**Critique of
*The Future of the Nuclear Fuel Cycle:
An Interdisciplinary MIT Study (2011)***

Developed by the Science Council for Global Initiatives
Contact: Tom Blee, tomsciencecouncil@gmail.com

Figure 1. Radiological toxicity of LWR spent fuel constituents as a function of time

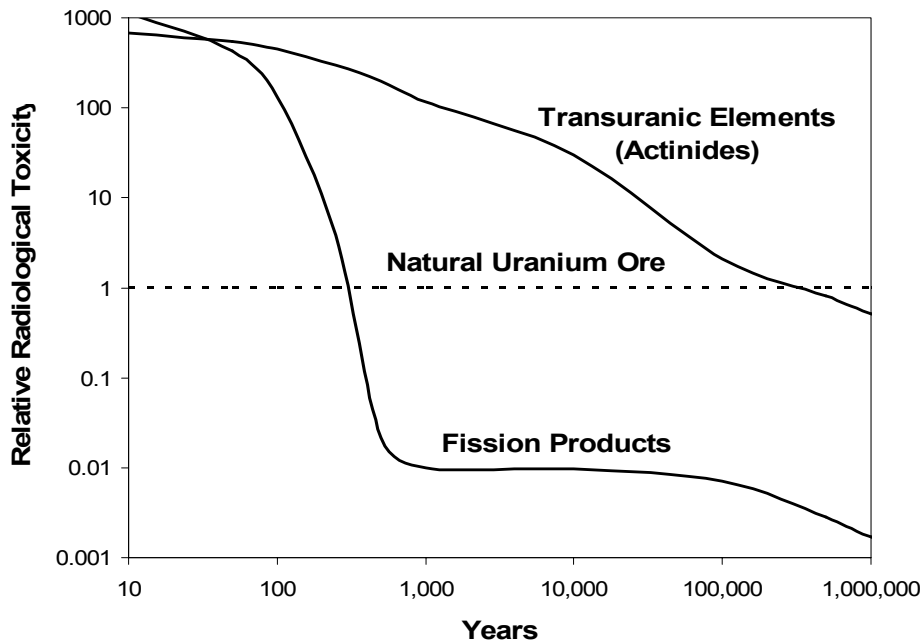
Radiological toxicity here is a relative measure of the cancer risk if ingested or inhaled, which we have normalized to that of the original natural uranium ore. As mined, the ore contains uranium along with decay products that have accumulated by its (very slow) decay over millennia. Normalization to the natural uranium ore from which the spent fuel originated is a useful but somewhat arbitrary relative standard. If the radiological toxicity drops below the natural uranium ore level we would be disposing of nuclear wastes that had no greater hazard than the uranium found naturally. The point at which the radiological toxicity curve crosses the natural uranium line then can be defined (at least loosely) as an effective lifetime of the waste components.

For all practical purposes, the radiological toxicity due to the fission product portion of the waste decays with (approximately) a 30 year half-life, due to the dominance of strontium and cesium isotopes. It drops below the natural uranium ore level in about 300 years, and becomes harmless in well under 1,000 years. On the other hand, the radiotoxicity level associated with the actinide portion stays far above that of natural uranium ore for a very long time, and remains at least three orders of magnitude higher than that for the fission products for hundreds of thousands of years. This is why following the National Academy of Sciences Committee recommendation, the EPA standards and NRC regulations for the Yucca Mountain repository extended the regulatory timeframe from the original 10,000 years to one million years.

The important point is this: if 99.9% of actinides could be removed from the waste form, then the radiological toxicity of the remaining 0.1% actinides would stay below the level of natural uranium ore at all times and the effective lifetime of the waste would be dictated by the fission products. If the actinides were mostly removed from the waste stream, the EPA standards and the NRC regulations [whether they cover 10,000 years or millions of years] can be met on an *a priori* basis.

Needless to say, this is an extraordinarily important fact, and the MIT Study ignored it.

Figure 2. Specific Inventory vs. Reactor Size (MWe) Figure 3. Range of Breeding Ratios

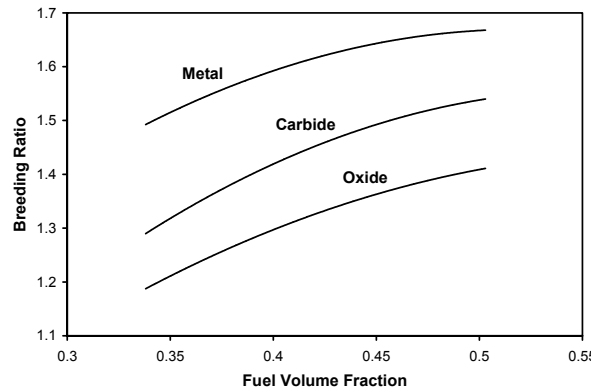
- The analysis used ALMR (PRISM Mod B) as the representative fast breeder reactor design, with a specific inventory (kg fissile material per megawatt electric) about a factor of two too high. The specific actinide inventory is presented here in Figure 2 as a function of the reactor size.

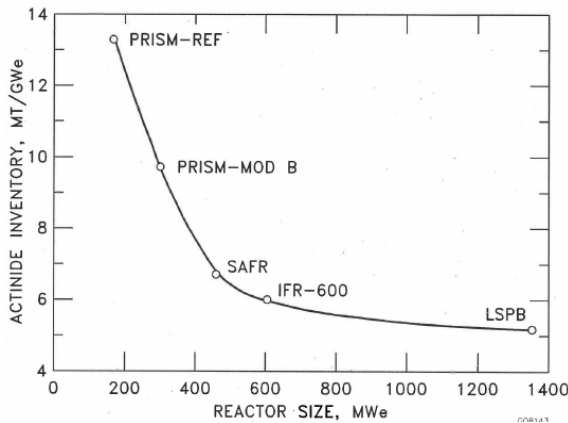
- A breeding gain of 0.23 was assumed, which is too low by a factor of two or three. The breeding ratio potential for what we'll call "advanced" fast reactors is presented in Figure 3 for various fuel types. Here, breeding ratio is the net gain in fissile material over some period of time, compared to the fissile loss from power generation. The metal fuel developed during the Integral Fast Reactor (IFR) program has become the reference fuel in the U.S. It has a breeding ratio potential in the range of 1.50–1.65. In the early years of deployment, the high breeding gain is not needed, but it is there from the start, and it can be used by simply deploying more U^{238} "blankets"—reflector regions actually—to capture a higher fraction of the neutrons leaving the core. If you don't need the plutonium early in fast reactor deployment, you would not load full blankets. A key advantage of the fast reactor design is that the plutonium production rate can be easily tailored to plutonium demand.

Figure 4. Example scenario for worldwide nuclear energy growth

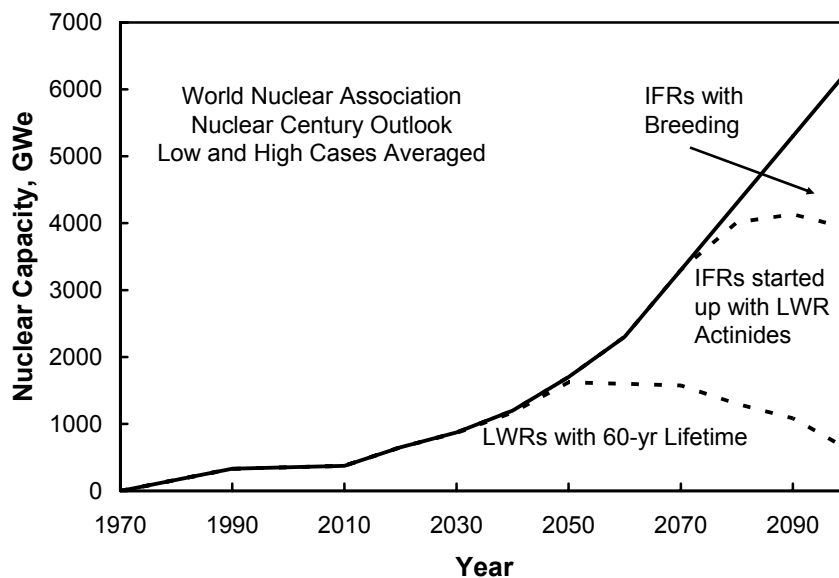
An example of nuclear fuel cycle system analysis more properly done is illustrated in Figures 4 and 5. These figures depict a scenario for world-wide nuclear energy growth, and the impact of fast reactors on the cumulative uranium requirement is very clear. The introduction of breeders can cap the LWR capacity (Figure 4) and hence also cap the ultimate uranium requirements (Figure 5). The divergence of the cumulative uranium requirements (Figure 5) will continue to widen if the plot is extended beyond 2100.
